Access Compliance Report

Public Rights-of-Way

Intersection ID: 24516	Main Street: HUNTSCROFT_LN	Cross Street: SADDLEBURY_LN	Location: S
ADA ID: BDA642417081	Ramp Type: BlendTrans2	Initial Pass/Fail: Fail	Overall Compliance: No
Severity Score: 21.25			
Codes/Mitigation Info/Possible Solution		Field Measurements/Component Compliance

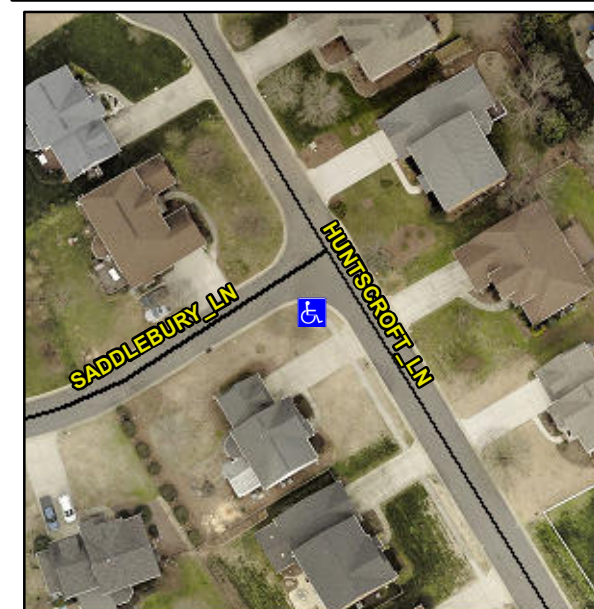
Not Found, R304.5.1, R304.5.3

Compliance	Description	Data	Compliance	Description	Data
N/A	Ramp Length (in)	99.0	Yes	BlendTrans Slope (%)	0.1
No	Ramp Width (in)	45.0	No	BlendTrans XSlope (%)	5.5
N/A	Flare Type LT	N/A	N/A	Flare Type RT	N/A
N/A	Flare Slope LT (%)	N/A	N/A	Flare Slope RT (%)	N/A
N/A	Flare Traversable LT?	N/A	N/A	Flare Traversable RT?	N/A
N/A	Landing Length (in)	N/A	N/A	DWS Provided?	N/A
N/A	Landing Width (in)	N/A	N/A	DWS Contrast?	N/A
N/A	Landing Slope (%)	N/A	N/A	DWS Length (in)	N/A
N/A	Landing X Slope (%)	N/A	N/A	DWS Full Width?	N/A
N/A	Landing Curb? (Y/N)	N/A	N/A	DWS Offset (in)	N/A
N/A	Shared Landing?	N/A			
N/A	Gutter Ponding?	N/A	N/A	Gutter Slope (%)	N/A
N/A	Gutter Lip Ht (in)	N/A	N/A	Gutter X Slope (%)	N/A
N/A	Painted X Walk1?	No	N/A	Painted X Walk2?	No
	X Walk 1 Direction	To NE		X Walk 2 Direction	To NW
	X Walk 1 Width (in)	N/A		X Walk 2 Width (in)	N/A
	X Walk 1 Slope (%)	10.2		X Walk 2 Slope (%)	3.6
	X Walk 1 X Slope (%)	2.2		X Walk 2 X Slope (%)	9.1

N/A	Ramp inside XWalk1?	N/A	N/A	Ramp inside XWalk2?	N/A
	Road Slope (%)	5.4		Clear Space?	N/A
	Road X Slope (%)	11.2	N/A	Clear Space to XWalk (in)	N/A
N/A	Any Obstructions?	N/A	N/A	Storm Grate/Utility Hazard?	N/A
	Obstruction Type			Storm Grate/Utility Type	
		N/A			N/A
			Yes	Surface Condition? (G/P)	Good
			No	Curb Slope (%)	7.9

Remove & Replace Curb Ramp With Two New Directional Ramps or Equivalent.
